SUBJECT: ISSUANCE OF AMENDMENTS NOS. 184, 184, AND 181 TO FACILITY OPERATING  
LICENSES DPR-38, DPR-47, and DPR-55 - OCONEE NUCLEAR STATION,  
UNITS 1, 2, AND 3 (TACS 68064/68065/68066)

SAFETY EVALUATION BY THE OFFICE OF NUCLEAR REACTOR REGULATION  
RELATED TO AMENDMENT NO. 184 TO FACILITY OPERATING LICENSE DPR-38

OCONEE NUCLEAR STATION, UNITS 1, 2 AND 3

Oconee Nuclear Station  
Figure 3.5.2-16

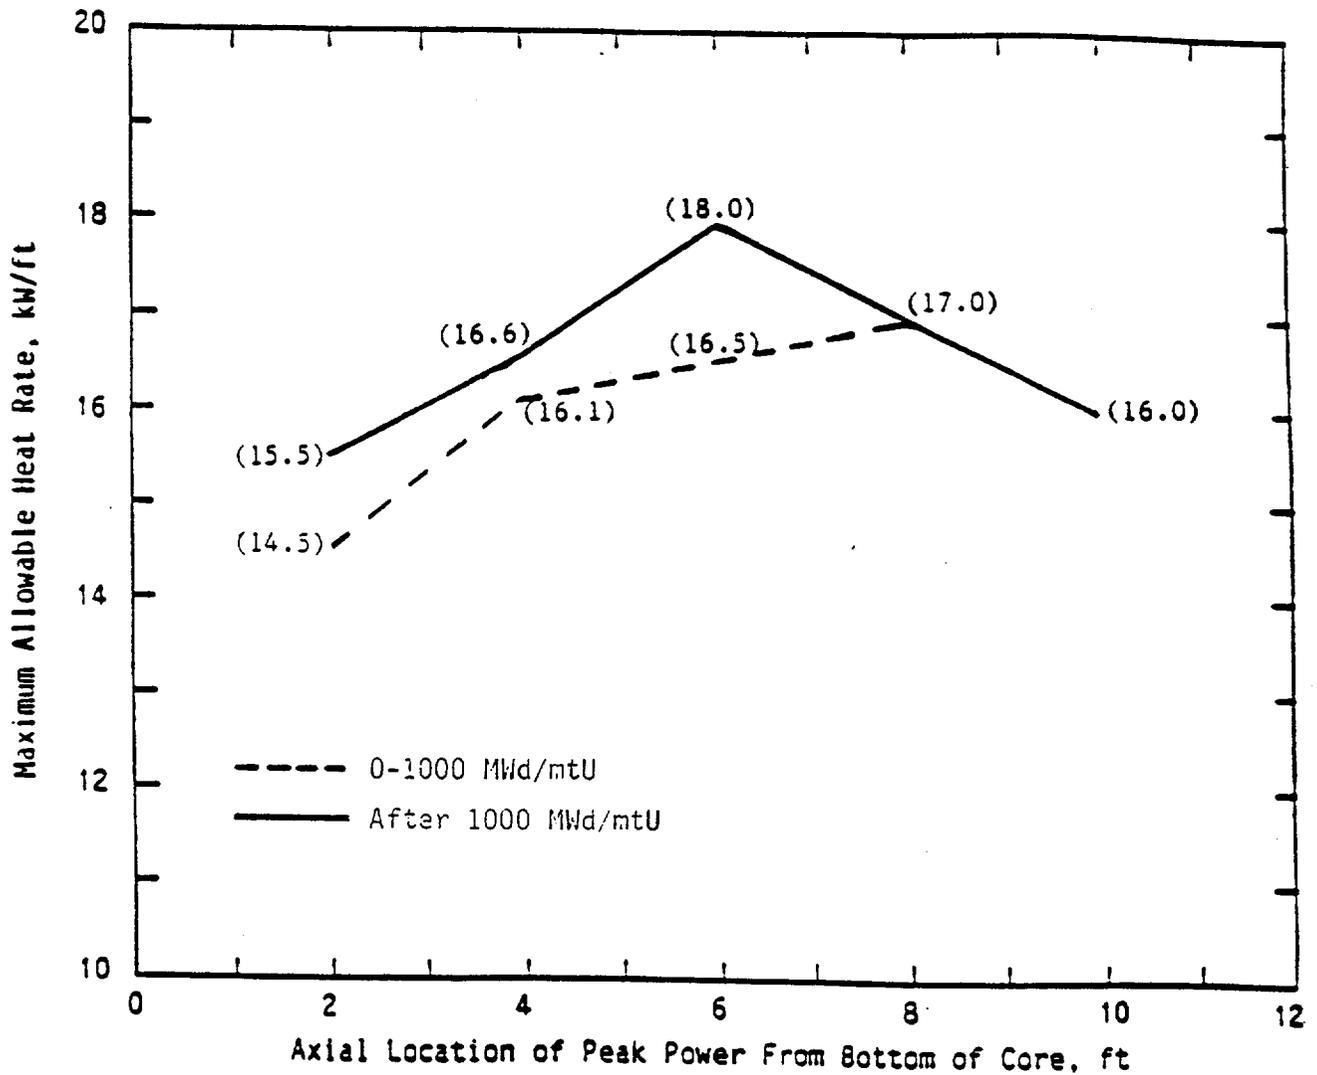
The TSs revised by these amendments allow an increase in the maximum linear heat rate at the 2-foot core level for specified periods of fuel burnup.

By letter dated January 22, 1988 (Ref. 1), Duke Power Company, licensee for the Oconee Nuclear Station (ONS), Units 1, 2, and 3, proposed a revision to Technical Specification (TS) Figure 3.5.2-16 for the loss of coolant accident (LOCA)-Limited Maximum Allowable Linear Heat Rate (LHR). The results of the analysis in BAW-2001P (Ref. 2) were provided in support of a peak power limit increase from 14.0 to 14.5 kW/ft for the 0-1000 megawatt days per metric ton uranium (MWd/mtU) burnup parameter. A modification was submitted in a letter dated October 9, 1989 (Ref. 3) for the elimination of the 1000-2600 MWd/mtU burnup parameter. The NRC staff review of the BAW-2001P report was limited to its applicability to the Oconee plant for the increase in LOCA-Limited Maximum Allowable LHR.

The design change made by the licensee was a reduction by 50 psi in the fuel rod pre-pressure, resulting in a reduction of the internal pin pressure during plant operation. The reduced internal pin pressure (1) allows for longer burnup periods (fuel cycles), and (2) delays the time to clad rupture during a LOCA. An evaluation by the licensee indicated that the pin pre-pressure reduction would delay rupture by a time increment equal to a rise in the LHR of .5 kW/ft. The LOCA analysis, therefore, utilized an increased LHR of 14.5 kW/ft, as compared to the current 14.0 kW/ft limit at the 2-foot core elevation for the 0-1000 MWd/mtU burnup parameter.

In a letter dated October 9, 1989 (Ref. 3), the licensee modified their original proposal to eliminate the 1000-2600 MWd/mtU burnup parameter and to have the "after 2600 MWd/mtU" burnup parameter relabeled "after 1000 MWd/mtU." This change is in agreement with the tabulated results in Table 3-2 of the BAW-10104 report (Ref. 5), which was approved by NRC in a letter dated October 12, 1987 (Ref. 10), and is therefore acceptable.

- (1) The reduced pin pressure results in delayed rupture and, consequently, lower peak cladding temperatures for the same LHR.
- (2) The reduced pin pressure maintains lower internal pin pressures for the entire fuel cycle.
- (3) Based on the reanalysis of the 2-foot core elevation LHR, as reported herein, the 2-foot peak power location LOCA LHR limit as shown in TS Figure 3.5.2-16, can be raised from 14.0 kW/ft to 14.5 kW/ft for the 0-1000 MWd/mtU burnup parameter for the Oconee Nuclear Station, Units 1, 2 and 3. Also, the 1000-2600 burnup parameter can be removed because of the results provided in the approved report BAW-1915.
